Application for Variation of an Environmental Permit

**Agreement No. CE 6/2015 (EP)
West New Territories (WENT)
Landfill Extension – Design and
Construction**

Supporting Document for Variation
of Environmental Permit

Drawing title
**GENERAL PLAN
 OF ORIGINAL SCHEME**

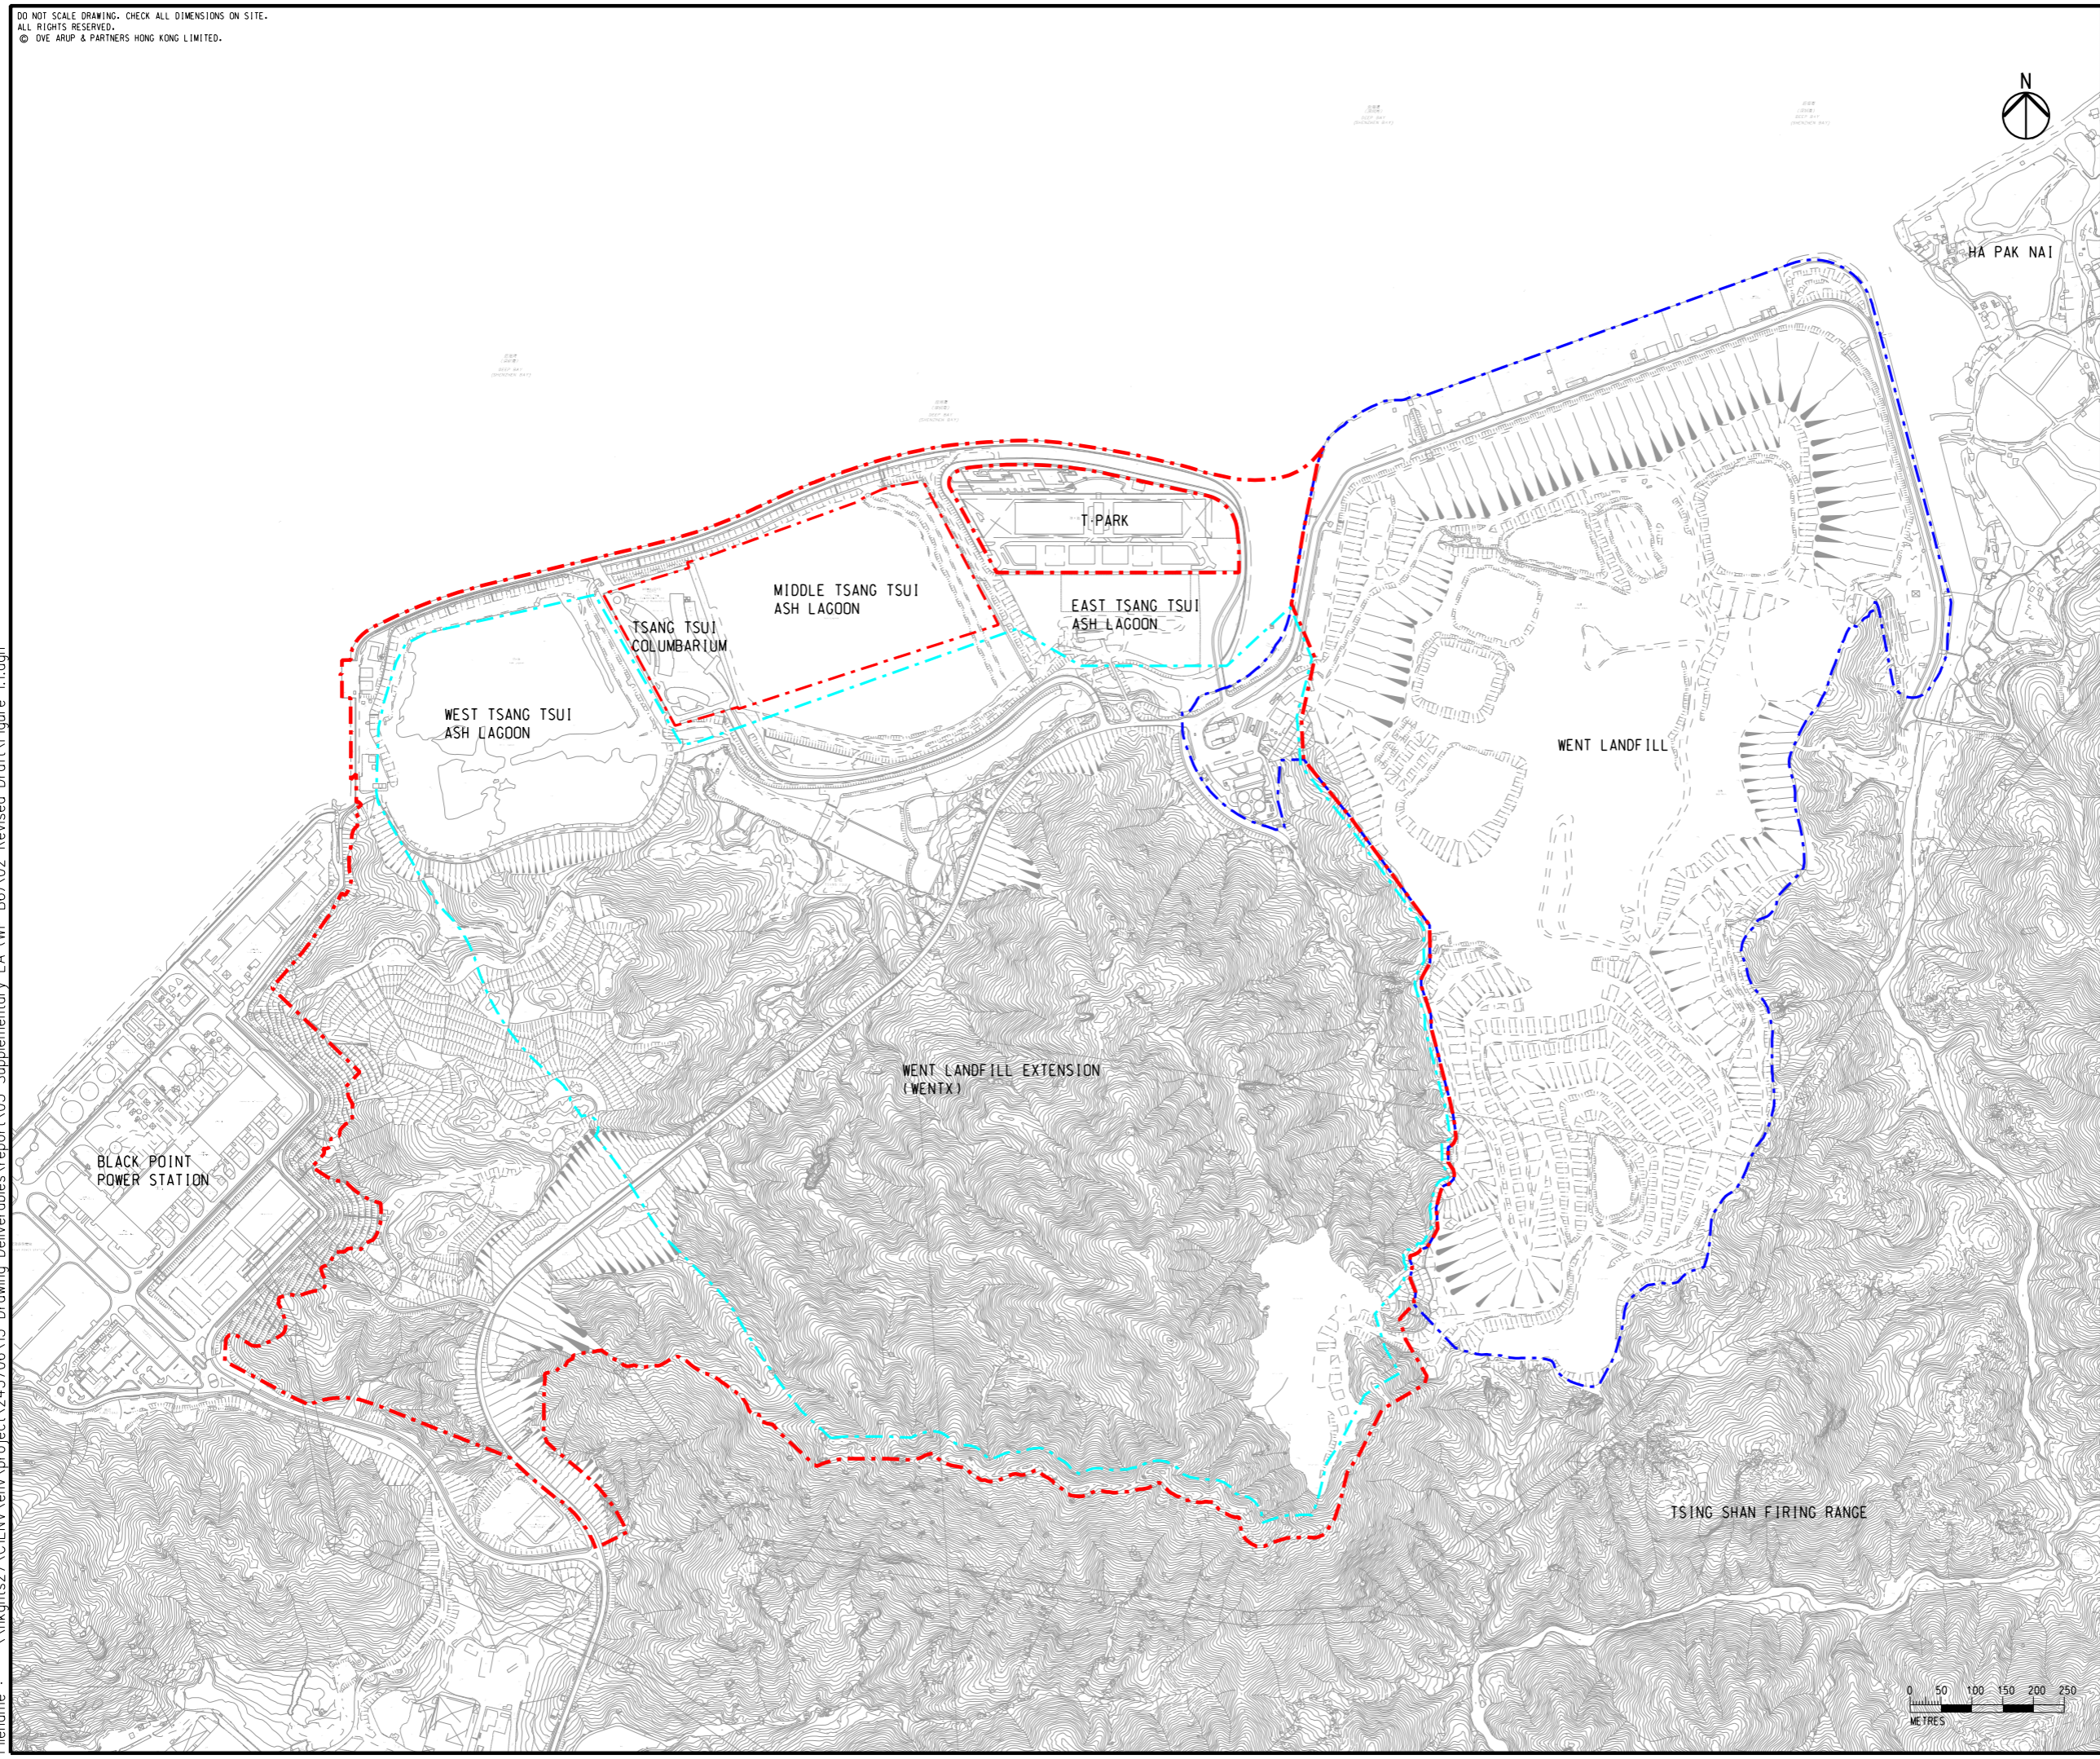
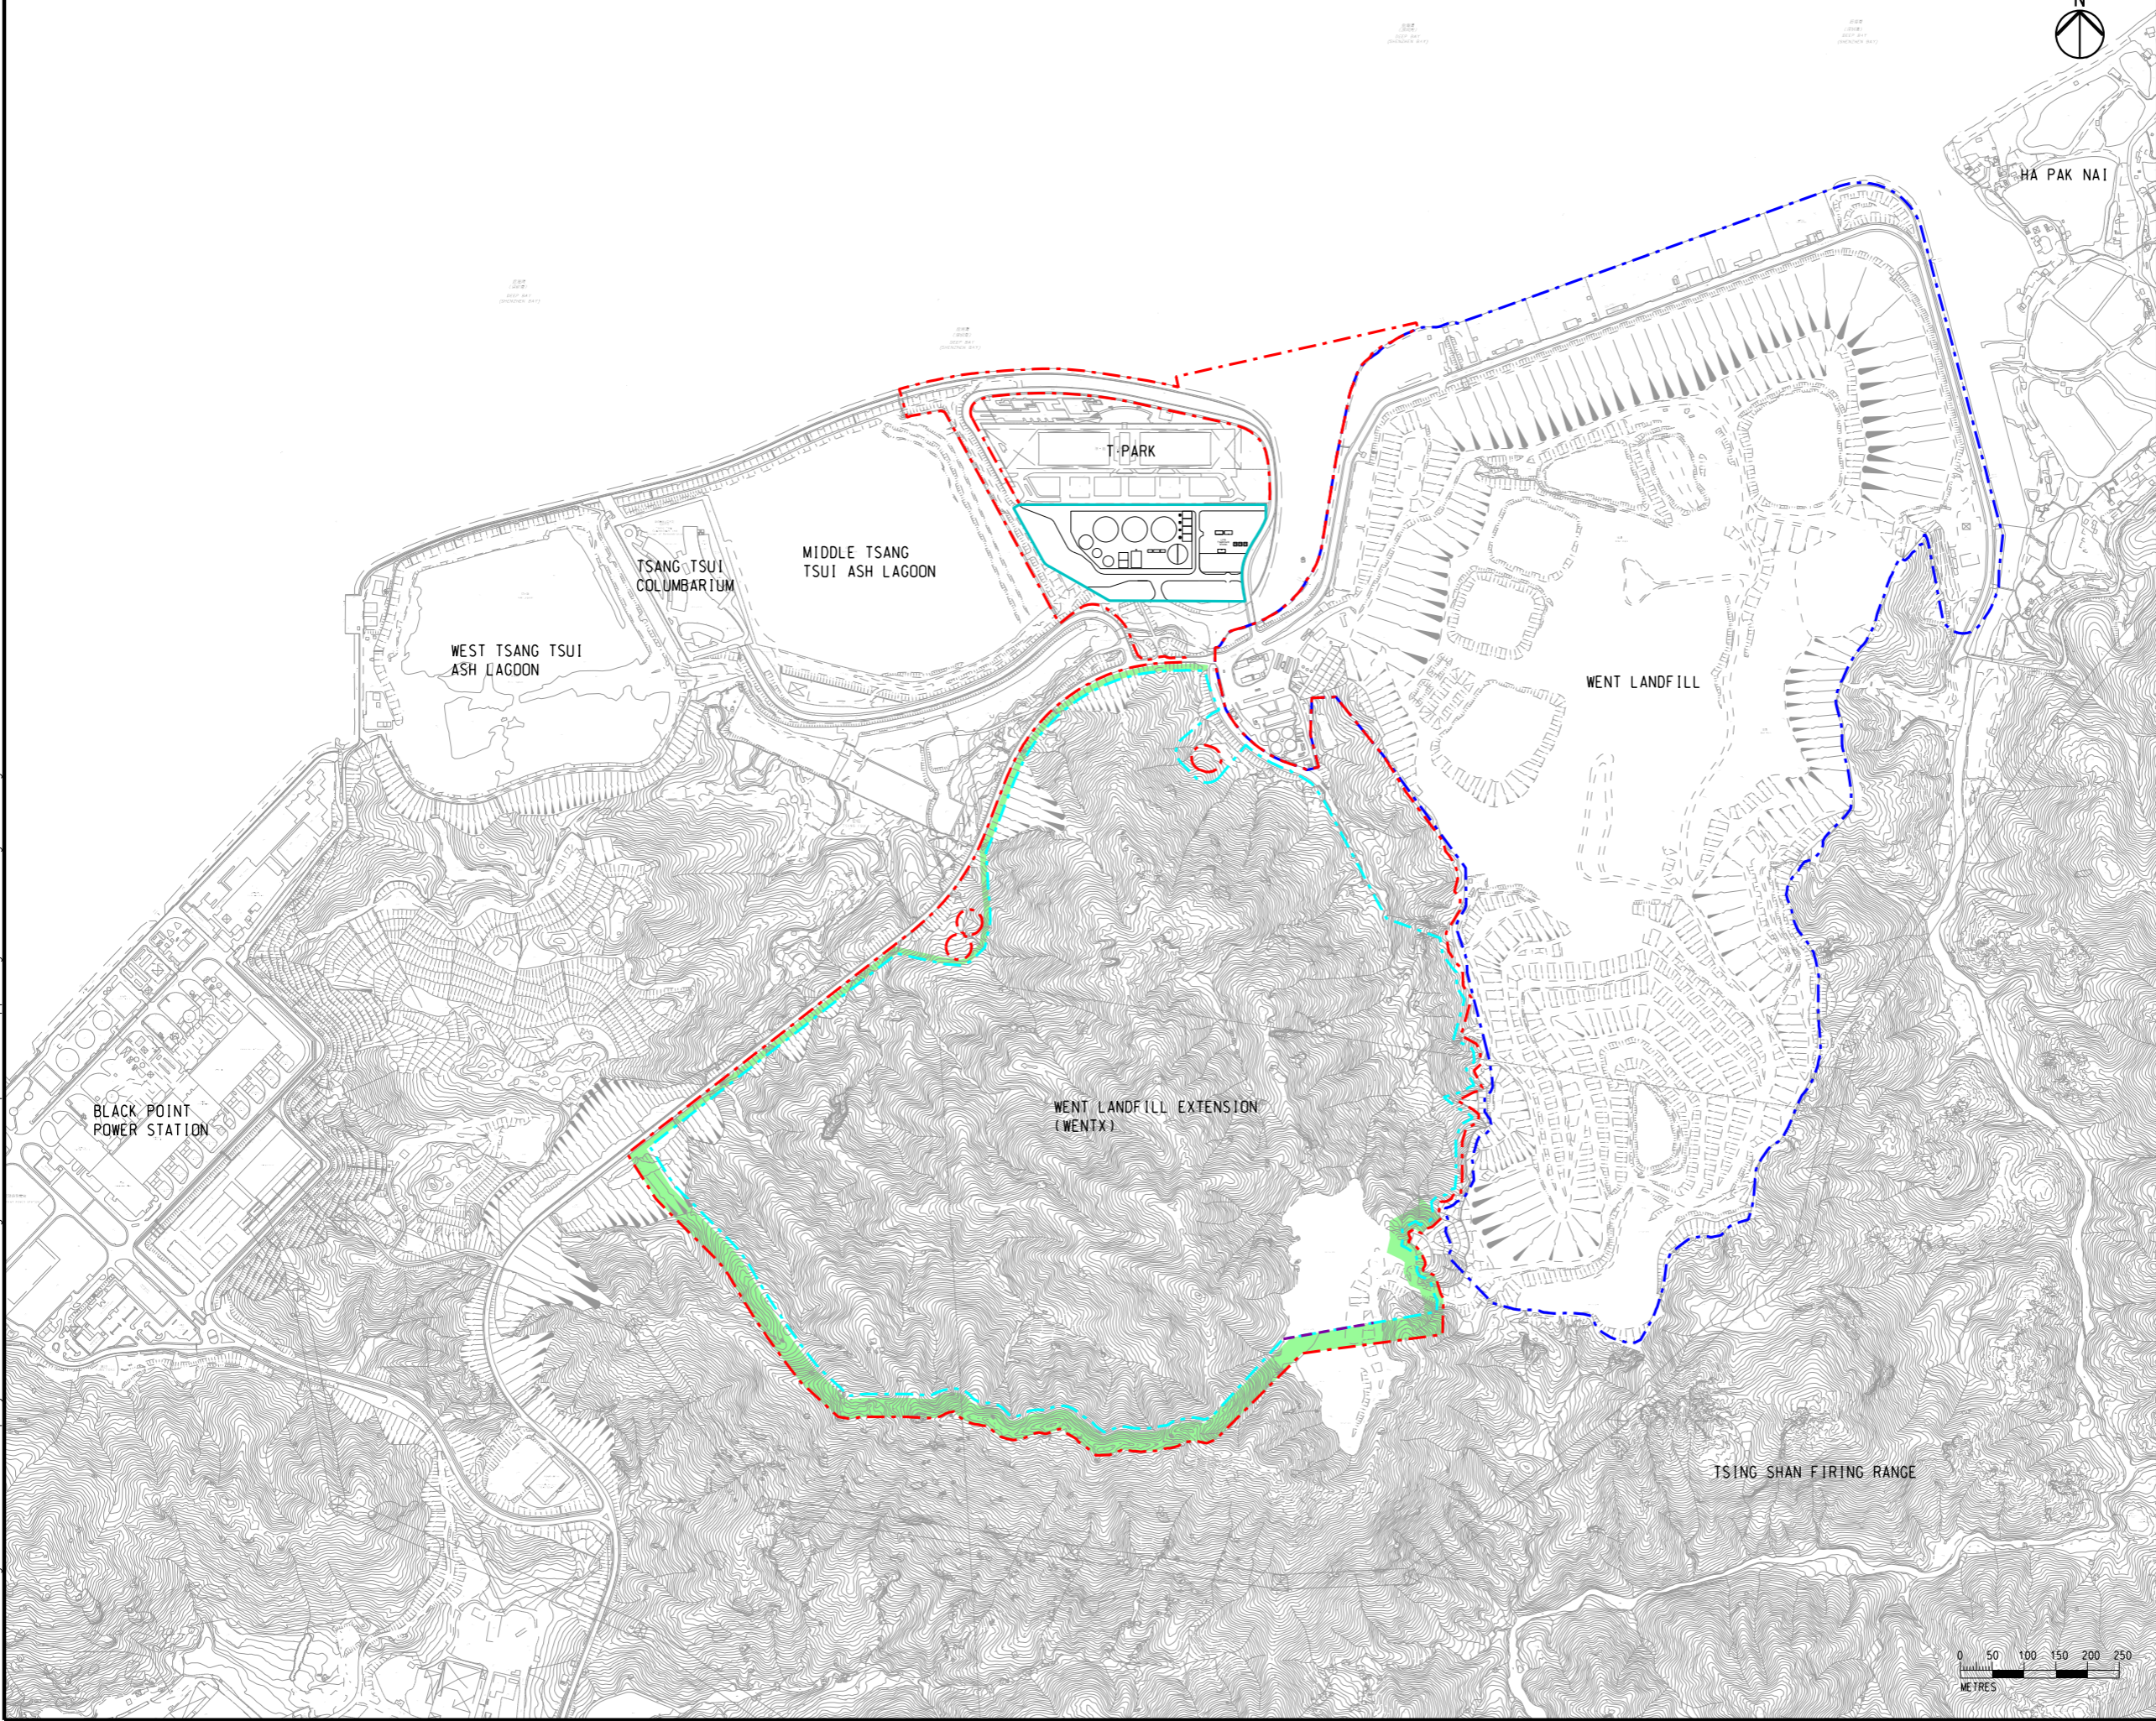
1.1.2 Since then, a number of interfacing projects, commitments and neighbourhood enhancement initiatives have been proposed and considered in conjunction with the Project. Compared with the Original Scheme (as shown in **Figure 1.1**), the following changes and considerations are identified and have implications on the site layout and hence the development of the Project under the Original Scheme:

1.1.3 In considerations of the above, the reference design and implementation programme for the WENTX (hereby referred to the Enhanced Scheme) has been revised. The major design changes and revised layout design are shown in **Table 1.1** and **Figure 1.2** respectively.

Design Parameters	Original Scheme	Enhanced Scheme
Waste Filling Area	188 ha	94 ha
Design Landfill Capacity	81 Mm ³	76 Mm ³
Anticipated Development Phasing (subject to contractor's design)	clock-wisely from east to north	from north to south
